CONTAINMENT SAFETY EVALUATION REPORT

Docket No. 71-9337

Model No. 3979A

Certificate of Compliance No. 9337

Figure 4-1 of CTR 2008/10, Rev. 2

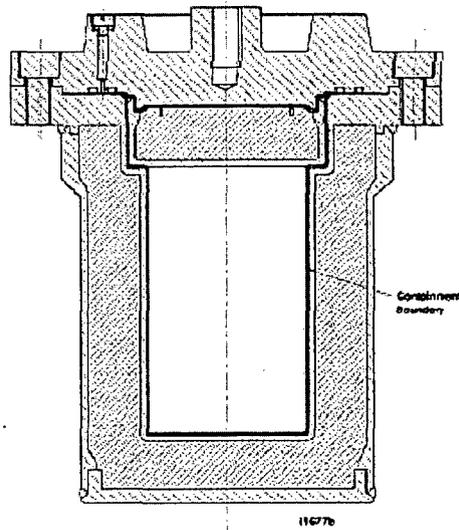
The containment boundary of the Safkeg-LS 3979A package is formed from the containment vessel (CV) flange/cavity wall, lid top and containment seal O-ring, as shown in Figure 4-1.

The lid top is sealed to the flange/cavity wall by the containment seal O-ring which is fitted in a face seal configuration with the O-ring recessed into the flange. The lid top is held in position with 8 alloy steel closure screws which screw into the containment vessel flange/cavity wall and lid and are tightened to a torque of 10 ± 0.5 Nm. On tightening the closure screws a uniform and repeatable compression of the O-rings is provided.

The closure screws are recessed into the lid top to physically protect them from damage. There is also a shear lip in the lid top and flange protecting the screws from shear failure due to transverse impact loads. The closure screws are positive fasteners, that cannot be opened unintentionally, or by any pressure that may arise within the package.

There are no valves or pressure relief devices present in the containment boundary and the package does not rely on any filter or mechanical cooling system to meet the containment requirements. There is a weld present in the containment boundary as shown on Detail A of Drawing No. 1C-6044, Issue C and Detail B of Drawing No. 1C-6045, Issue C. However, the weld is needed to hold the lead shielding in position, and does not fulfill any containment requirement.

Figure 4-2 of CTR 2008/10, Rev. 2

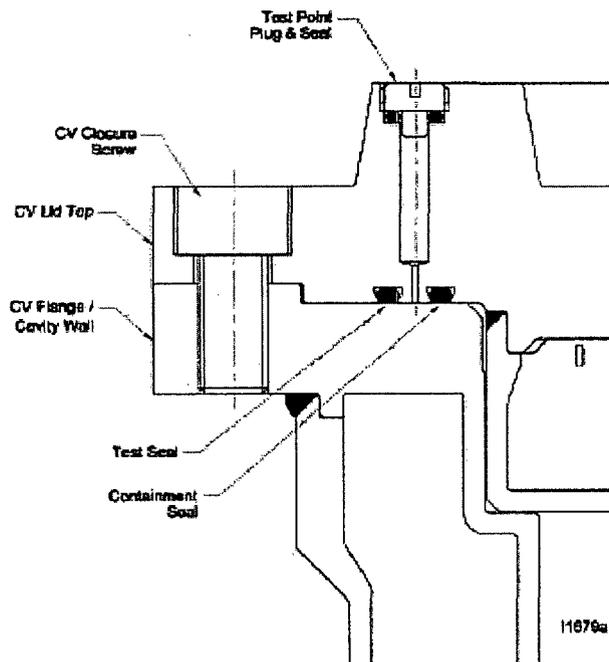
Figure 4-2, of CTR 2008/10, Rev. 2 shows the two additional O-ring seals fitted to the CV: a test point seal, and a test seal. These seals are present to facilitate the leak test of the containment seal during the pre-shipment leak test. The test point is a tapped hole that allows connection of a pressure drop leak tester to the interspace volume between the test seal and the containment seal. The test seal is located close to the containment seal to provide a small interspace volume thus increasing the sensitivity of the pressure rise leakage test. The inserts as specified in section 1.2.2.2 are also fitted with an O-ring seal. The test point seal, the test seal, and the insert seal are not relied upon for containment.
